ADDENDUM NO. 3

**South Fountains Restoration
Missouri State Capitol Building
Jefferson City, Missouri
PROJECT NO.: 02204-01**

JUNE 3, 2025

EAST FOUNTAIN LANDSCAPE ENLARGEMENT 02
SCALE 1" = 5'

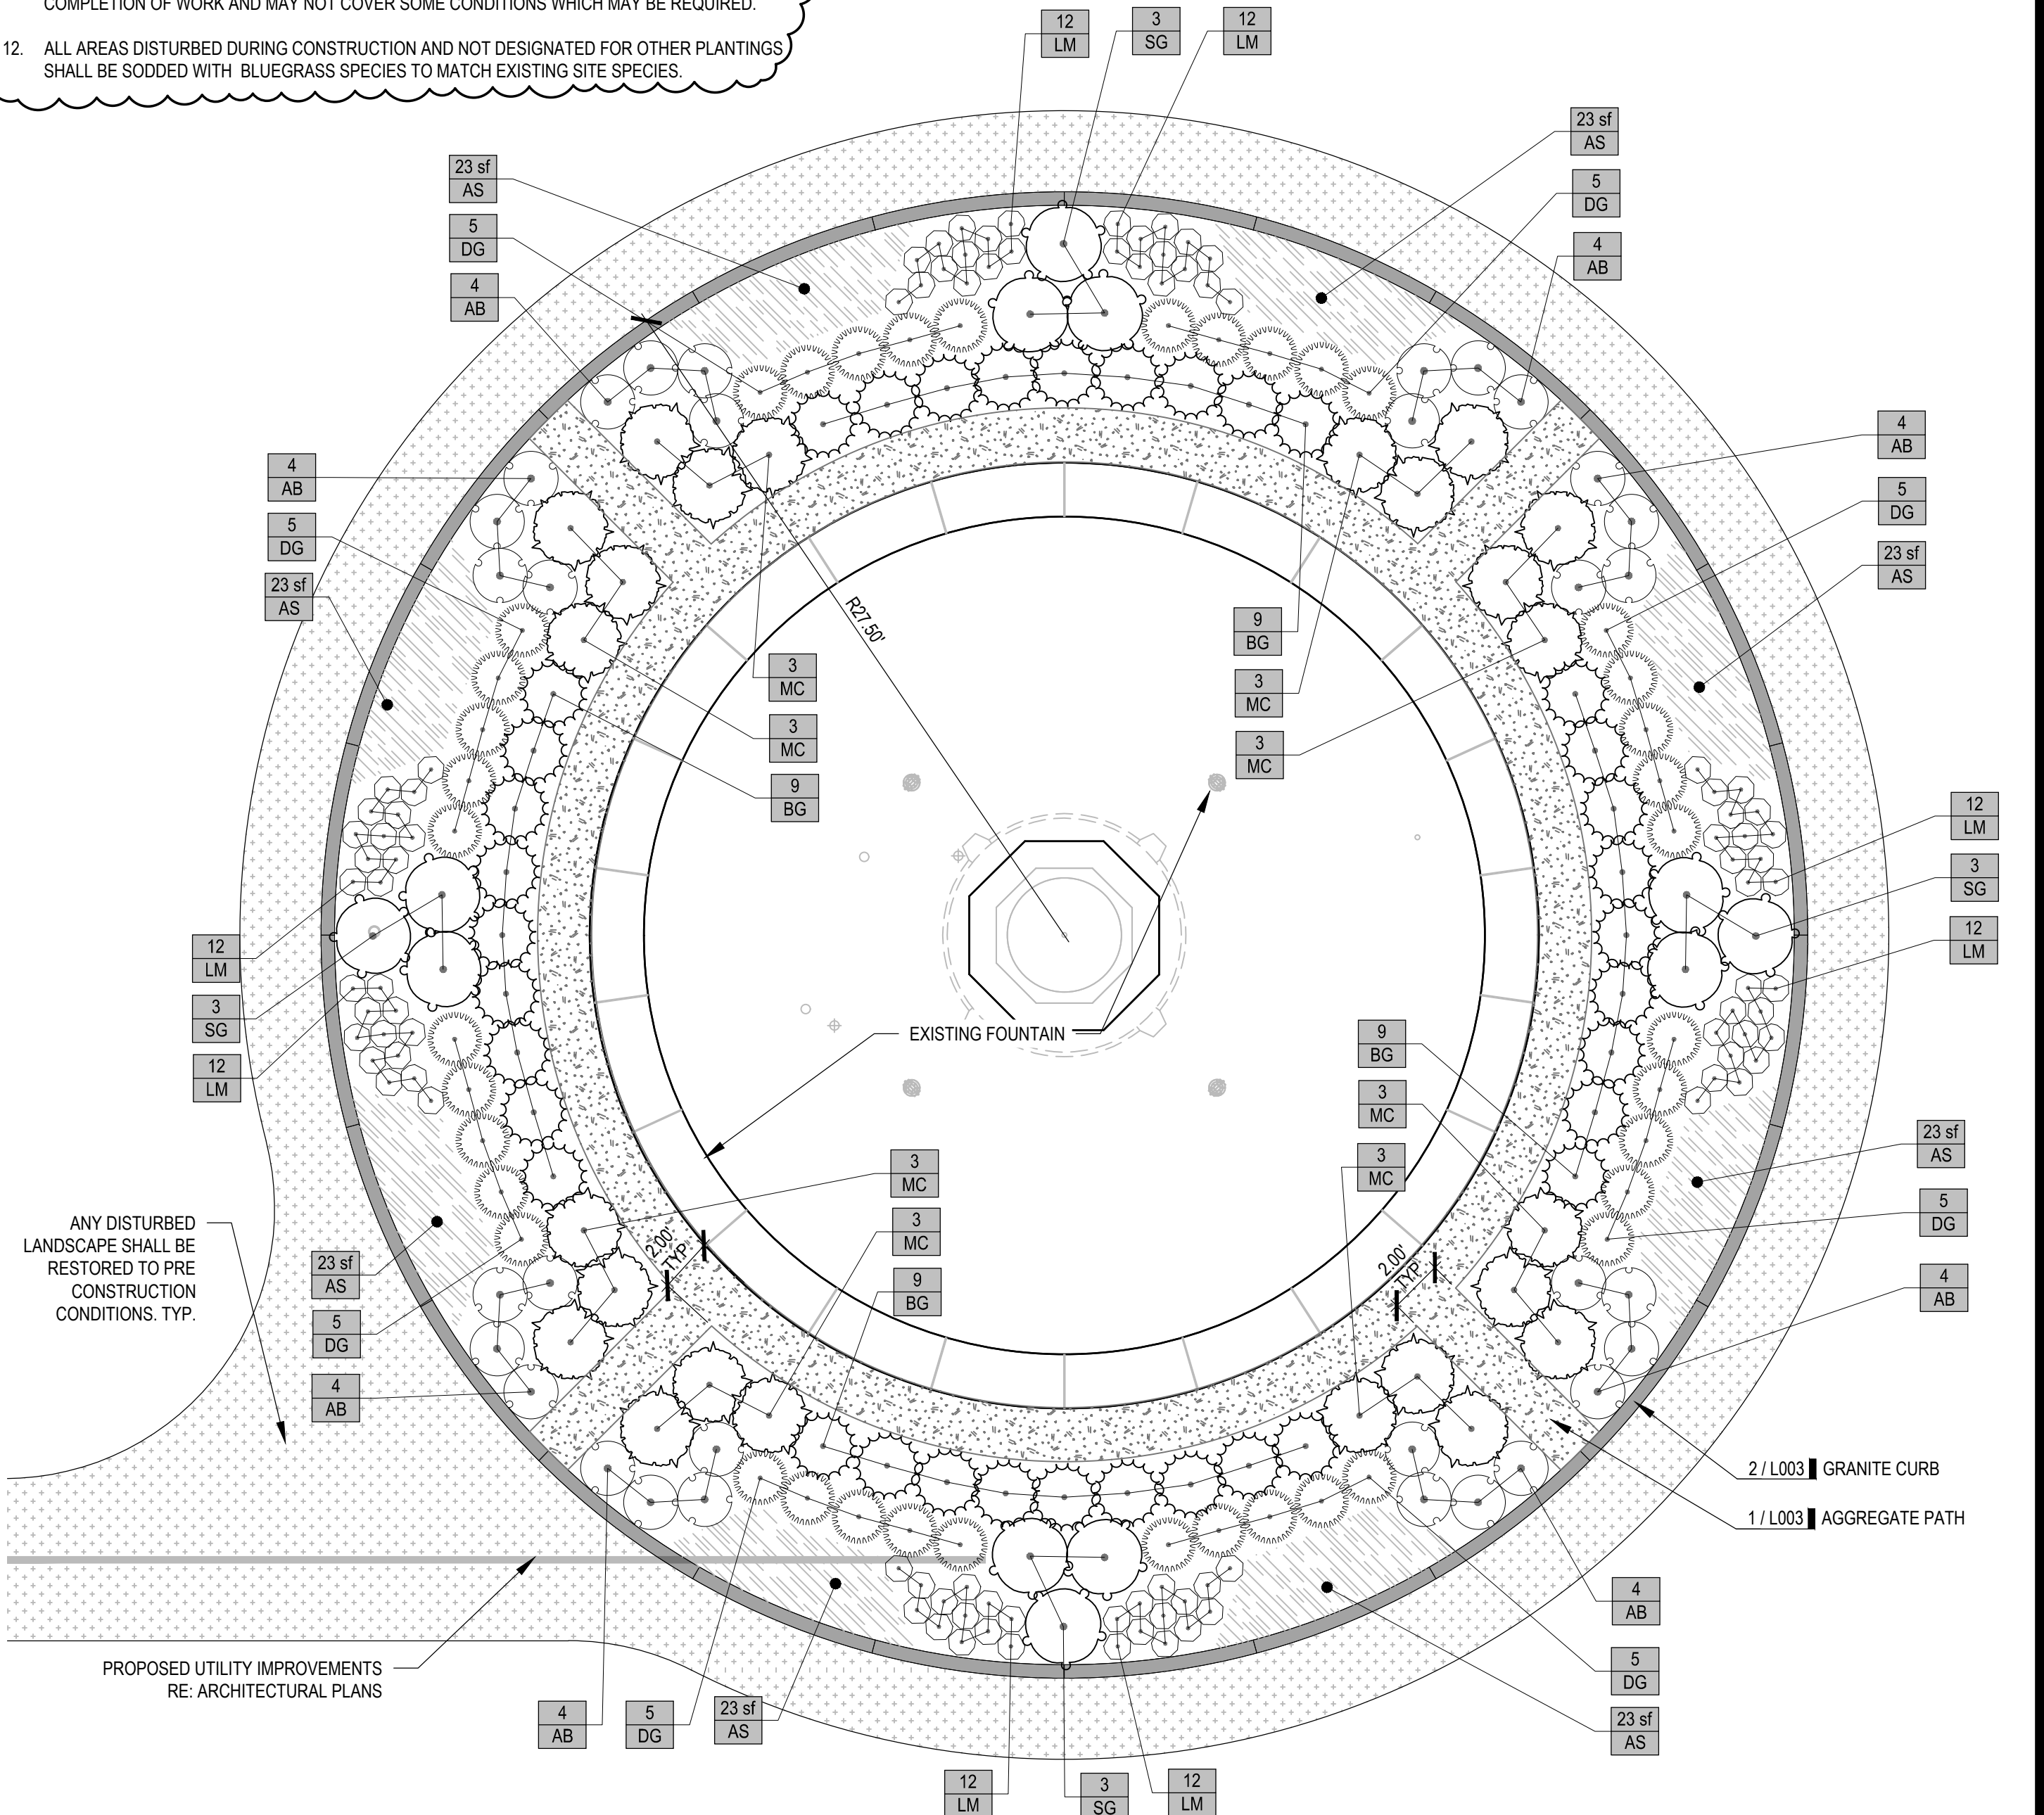
3. Sheet L002
 - a. REVISE West Fountain plant schedule GROUND COVERS RP Restoration Planting to include sod, not seed.
 - b. REVISE East Fountain plant schedule GROUND COVERS RP Restoration Planting to include sod, not seed.

- c. REVISE Layout & Grading Note 9 as follows:
 9. All areas shall be brought to final plan condition (paved, soded, or mulched) as soon as possible to maintain finish grade conditions and prevent soil loss.

- d. REVISE Layout & Grading Note 12 as follows:
 12. All areas disturbed during construction and not designated for other plantings shall be soded with bluegrass species to match existing site species.

GROUND COVERS					
	AS	Annual Planting Soil		RE: SPEC	
	RP	Restoration Planting	Match Existing Bluegrass Species	sod

9. ALL AREAS SHALL BE BROUGHT TO FINAL PLAN CONDITION (PAVED, SODED, OR MULCHED) AS SOON AS POSSIBLE TO MAINTAIN FINISH GRADE CONDITIONS AND PREVENT SOIL LOSS.

12. ALL AREAS DISTURBED DURING CONSTRUCTION AND NOT DESIGNATED FOR OTHER PLANTINGS SHALL BE SODED WITH BLUEGRASS SPECIES TO MATCH EXISTING SITE SPECIES.

3 SOUTH FOUNTAINS BASIN WALL SECTION
Scale: 1" = 1'-0"

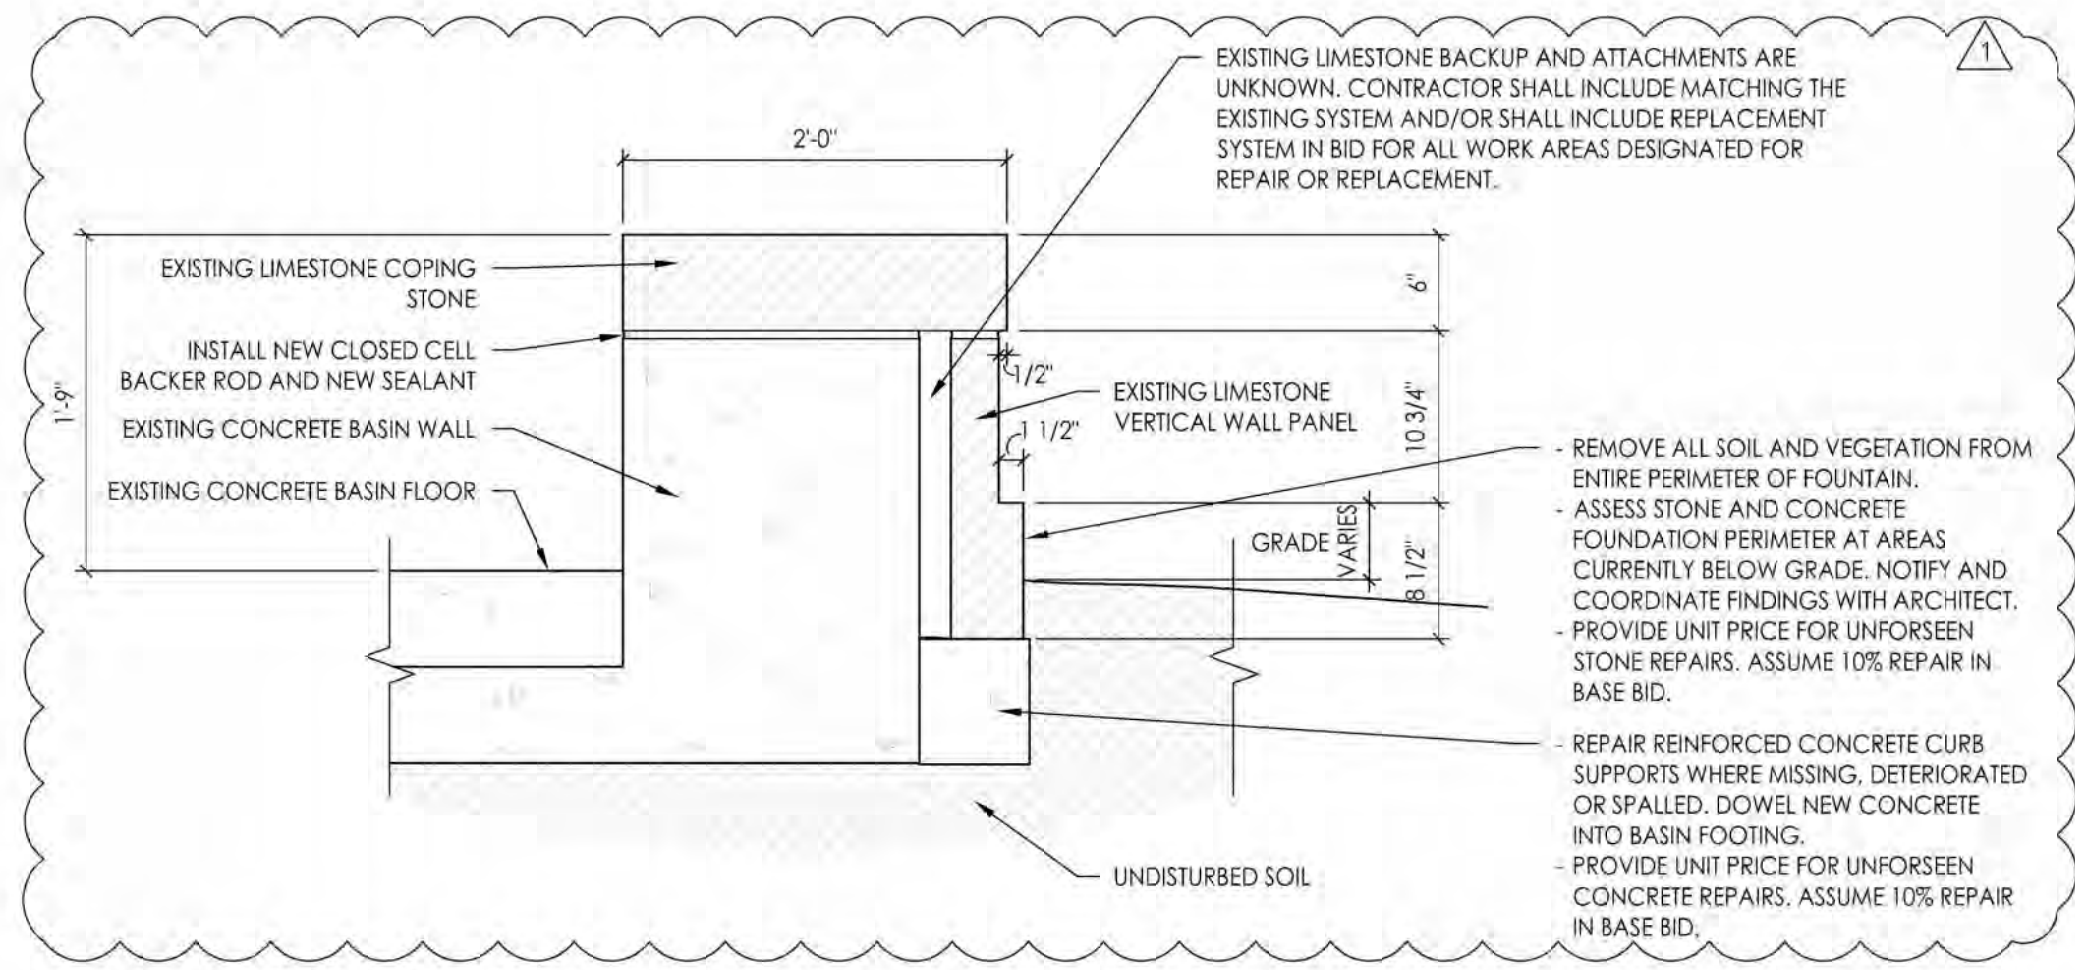
- K. Remove det'd stone area. Install dutchman repair (approx 6"X12") using adjacent historic salvaged stone cap.
- L. Spec 040120 – Remove (3) damaged full depth portions of limestone vertical panel. install full depth limestone dutchman patch at each location. Use removed and salvaged portion of historic stone for patches.
- c. Detail 1 – ADD fountain limestone coping slab repairs and replacements
See W1, W3, W9, W13, and W14
- d. Detail 3 – ADD Notes and Unit Price information as follows:

Existing limestone backup and attachments are unknown. Contractor shall include matching the existing system and/or shall include replacement system in bid for all work areas designated for repair or replacement.

Remove all soil and vegetation from entire perimeter of fountain.

Assess stone and concrete foundation perimeter at areas currently below grade. Notify and coordinate findings with architect.

Provide unit price for unforeseen stone repairs.

Repair reinforced concrete curb supports where missing. deteriorated or spalled. Dowel new concrete into basin footing.

Provide unit price for unforeseen concrete repairs.
